APPLICATION NO.	FILING DATE	FIRST NAMED INVENTOR	ATTORNEY DOCKET NO.	CONFIRMATION NO.
10/708,212	02/17/2004	CHUNG-CHE YU	11987-US-PA	2211
31561	7590	02/14/2006	EXAMINER	
JIANQ CHYUN INTELLECTUAL PROPERTY OFFICE			VO, TUYET THI	
7 FLOOR-1, NO. 100			ART UNIT	
ROOSEVELT ROAD, SECTION 2			PAPER NUMBER	
TAIPEI, 100			2821	
TAIWAN			DATE MAILED: 02/14/2006

Office Action Summary

Applicant's arguments filed August 15, 2005 and the election of restriction filed December 9, 2005 have been fully considered but they are not persuasive due to a new prior art that has been applied against the election of invention I, including claims 1-3 and 8, as below.

FIG. 7

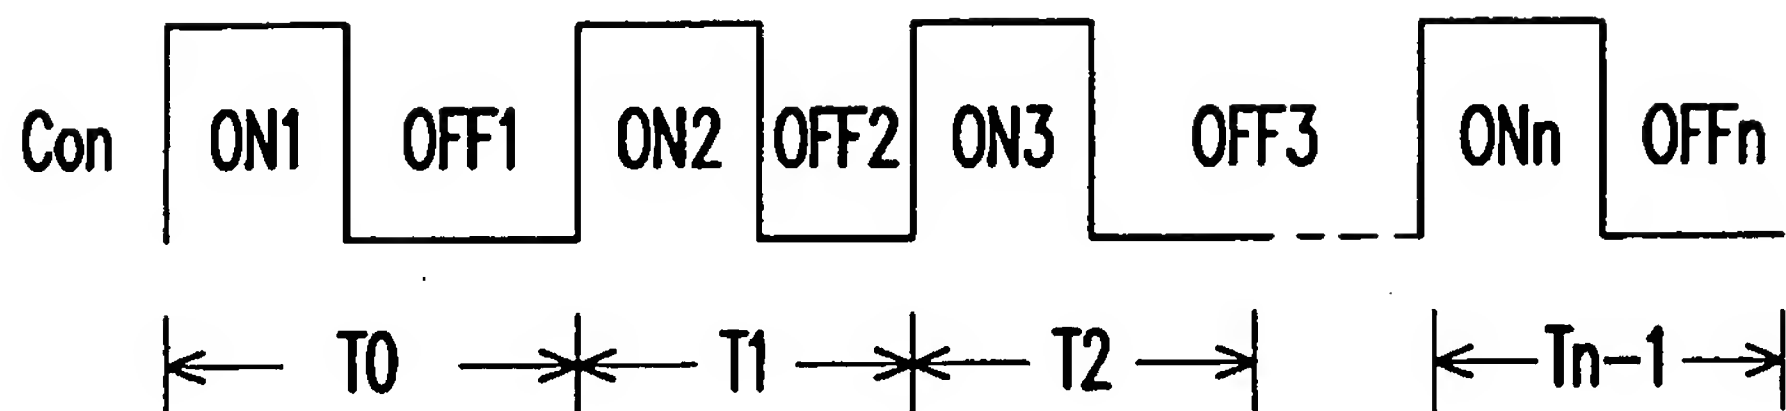
Xu discloses a pulse width modulation illumination control circuit (Fig. 7) for controlling the illumination of light emitting diodes (24, [0028]), comprising:

an illumination control pulse-generating unit (34), for receiving an illumination-adjusting signal (A, marked by examiner) and generating an illumination control pulse signal (B, marked by examiner) according to the illumination-adjusting signal (A), wherein a duty cycle of the illumination control pulse signal varies with time within a predetermined range; and

a DC/DC, buck, converter (D1, 30, 32), coupled to the illumination control pulse-generating unit (34) for driving the diodes (24) according to the illumination control pulse signal (A), wherein a phase shift, a frequency and a duty cycle of the illumination control pulse signal vary with time simultaneously within a predetermined range (Figs. 9 and 10).
